DEVELOPMENT DETERMINATION PANEL MEETING

WEDNESDAY 11 SEPTEMBER 2019

ITEM 3.1	DA2019/0246 - 49 GREYCLIFFE STREET, QUEENSCLIFF - ALTERATIONS AND ADDITIONS TO A DWELLING HOUSE
REPORTING MANAGER	Anna Williams
TRIM FILE REF	2019/498178
ATTACHMENTS	1 Assessment Report 2 Site Plan & Elevations 3 Clause 4.6

DEVELOPMENT APPLICATION ASSESSMENT REPORT

Figure 1. Shows the minimal change to the building height and bulk and scale of the proposed development (in black outline), when compared to the existing dwelling house (in red outline).

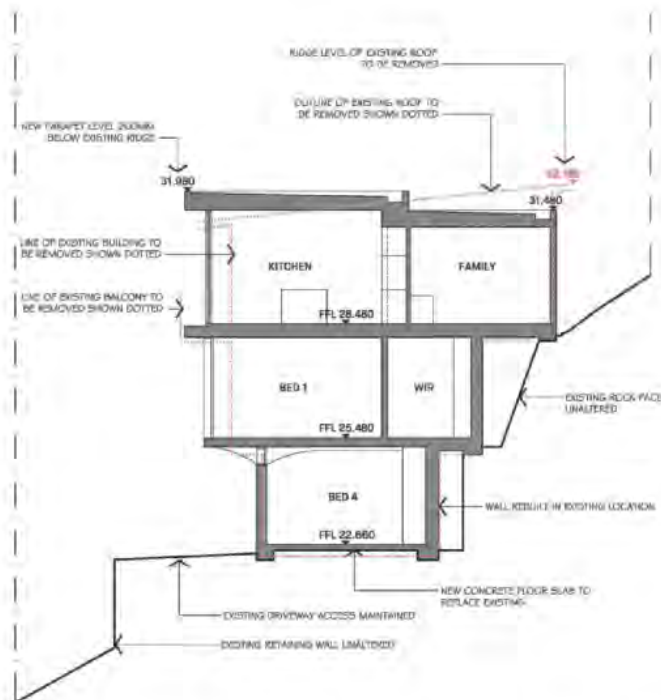
The development is for the construction of a new three (3) level dwelling house with a flat style roof. Whilst there is an increase in the building height of the proposed dwelling house from 8.8m to 9.6m, the proposed overall height of the development has been reduced from RL32.180 to RL31.980 (reduction of 0.2m) due to the flat style roof form. This flat style roof design assists to minimise the overall height of the development. See Figure 1 below.

The proposals building height and flat roof design reflects the established built form character of the immediate Abernethy Street area where multi-level, and non-complying building heights are prevalent due to the steep topography of the land and difficulty with pedestrian and vehicular access.

Figure 2. Shows the similar building bulk when viewed from the south-east.
north-west.

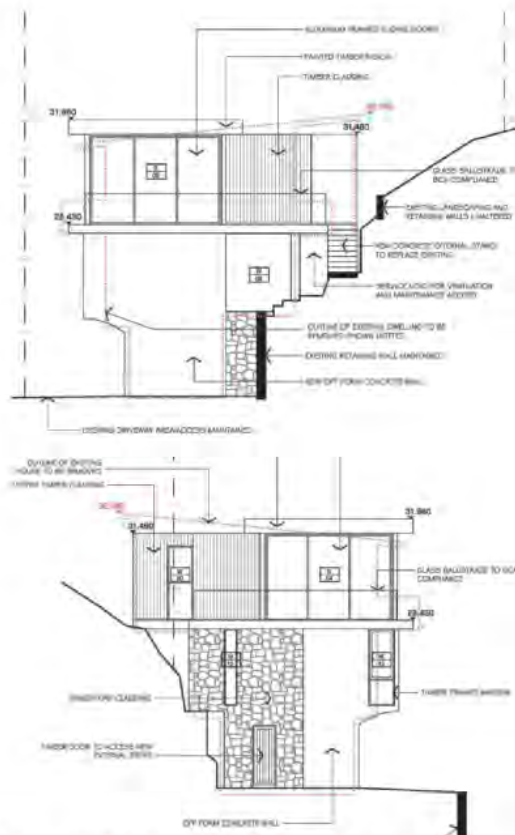
The building height non-compliance is located at the south-western edge of the roofline and wall plane of the second floor and is relatively minor in size.

The bulk and scale proposed development will continue to be a similar representation of the existing three (3) storey development when viewed from properties to the north-west and south-east, as demonstrated in Figure 2 and 3 below.
